Objective Design Standards & Project Streamlining Advisory Group Meeting #2

City of Oakland Objective Design Standards & Project Streamlining Advisory Group Meeting #2

September 7, 2023, 5-6:30pm, held on Zoom

Entrance Context

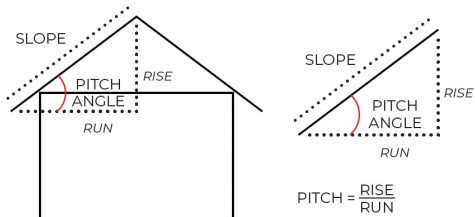
- Affordable housing gets funding from govt and must meet ADA requirements- ground floor units will have to be accessible, stoops won't work in this instance.
- Context-specific variables could be related to larger projects as well

Building Bulk

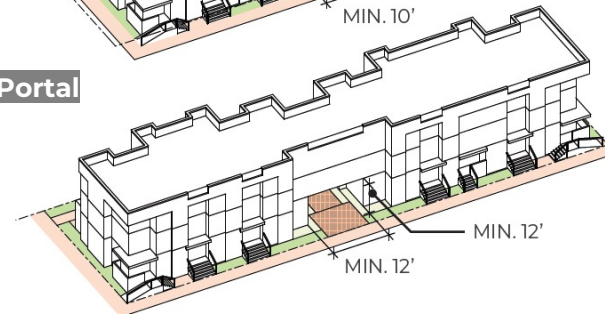
- You indicated buildings 100' long would need some articulation, e.g. a 15' portal, but it seems to me 100' should have more than one such articulation.
- Can be choppy
- The building on the left is chaotic and disturbing!

- Quarry building on MLK- a mile long, highly repetitive, beautiful- would you choose subjective?
- Maybe put in some **maximums**, not just minimums+2

- Question reliance on articulation, can be counterproductive an busy- façade rhythm, materials, context.
- What if it were developed over time, would I do it this way? Want more authentic massing breaks. Daylight corridor, more meaningful break.
